THE APPROVED DESIGN - HIGH & DRY

AS BUILT - FLOOD WATER DAMAGES WOOD CONSTRUCTION

REASONS FOR CODE COMPLIANCE AND LIFT TO EL 13.25

FOUNDATION AS-BUILT SURVEY 102 HIGHLAND AVENUE LOT 5 BLOCK 5412			FILE
TOWNSHIP OF NEPTUNE MONMOUTH COUNTY		NEW JERSEY	
Charles Surmonte P.E. & P.L.S. New Jersey Professional Engineer and Land Surveyor License No. 35885			301 Main Street, 2nd Floor Allenhurst, New Jersey, 07711 Phone 732-660-0606 Fax 732-660-0404
PROJECT No.	DATE:	SCALE:	SHEET:
15-1515	04-06-16	1"=20'	1 OF 1

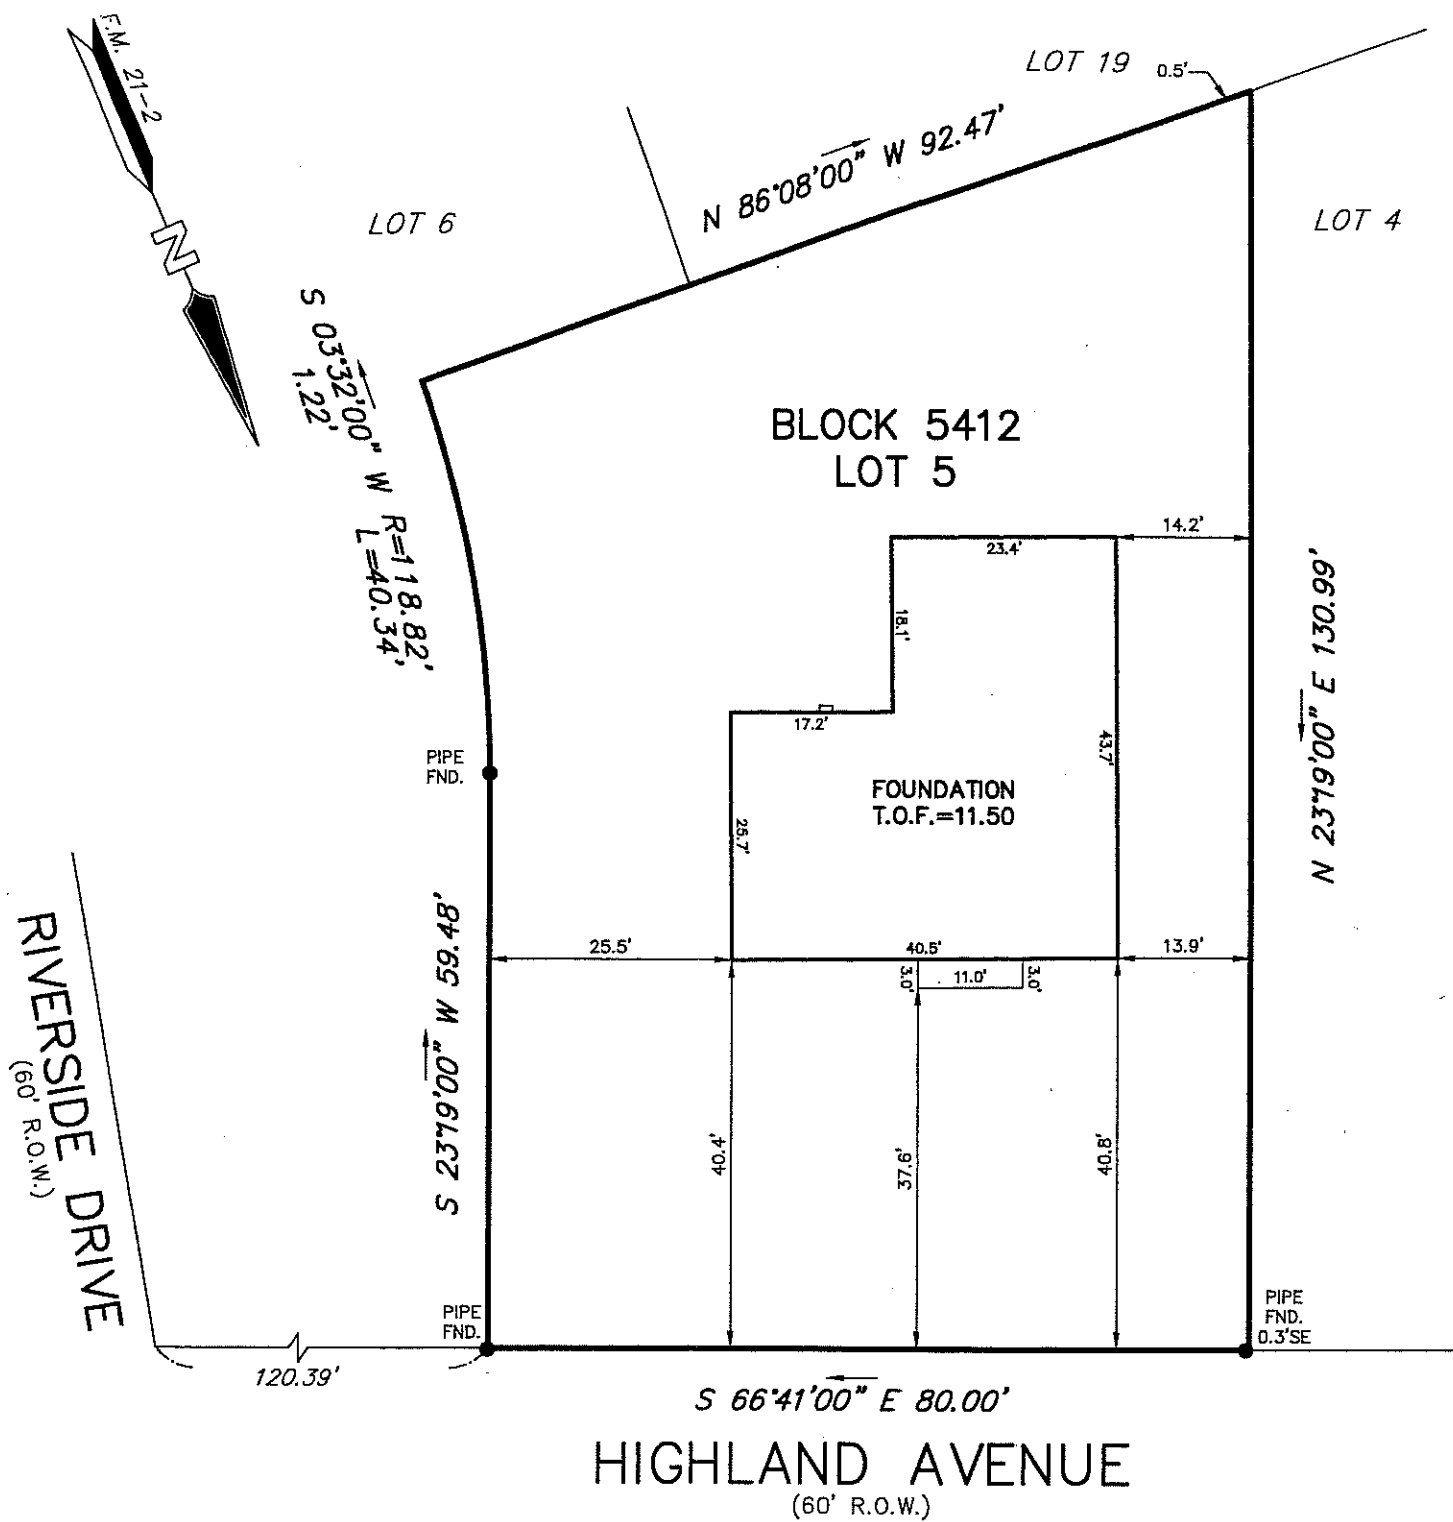
- 13.25 The approved Plans specified the Finished Floor Elevation ("FFE").
- 12.50 FFE from Flood Certificate.
- 12.44 Finished floor elevation, as calculated based on existing construction and the Surmonte 04/06/16 Foundation As-Built Survey [$11.50 + 0.12 + 0.76 + 0.06 = 12.44$].
- +0.06 *plus* the 3/4-inch subfloor.
- 12.00 Neptune flood elevation. Half of the floor joist height and the floor insulation is in the flood water.
- +0.76 *plus* the 9-1/2 inches tall engineered wood floor joists that are *not treated*. Half the joist is in the flood water.
- +0.12 *plus* the only 1-1/2 inch thick sill plate.
- 11.50 Surmonte 04/06/16 Foundation As-Built Survey and top of block elevation.

- 10.83 The bottom of the 9-1/2 inch deep engineered lumber beams that are set one course of block below the top of wall. There is no evidence that the engineered beam is *treated*.
- 10.50 Bottom of insulated HVAC main duct, flex lines droop lower.

4. As built, the wood floor joists and insulation are in the flood water.
5. As-Built, the HVAC main duct and plastic flex duct hangs below the floor joists in the flood water.

6. As-built, electrical wiring, receptacles, and lighting fixtures that are in the flood water.
7. The foundation walls leak.
 - a. The main building walls leak.

- 13.25 The approved Plans specified the Finished Floor Elevation ("FFE").
- 0.06 *less* the 3/4-inch subfloor.
- 0.76 *less* the 9-1/2 inches tall engineered wood floor joists that are *not treated*.
- 0.12 *less* the 2nd 1-1/2 inch thick sill plate.
- 0.12 *less* the 1st 1-1/2 inch thick sill plate.
- 12.19 Top of Foundation Block. All wood construction is above flood water. HVAC was not designed, flood proof installation always a contractor obligation.
- 12.00 Neptune flood elevation.
- 0.67 *less* the *treated* engineered lumber parallam beams.
- 11.52 Bottom of *treated* wood construction. Design anticipated *treated* beam getting wet.
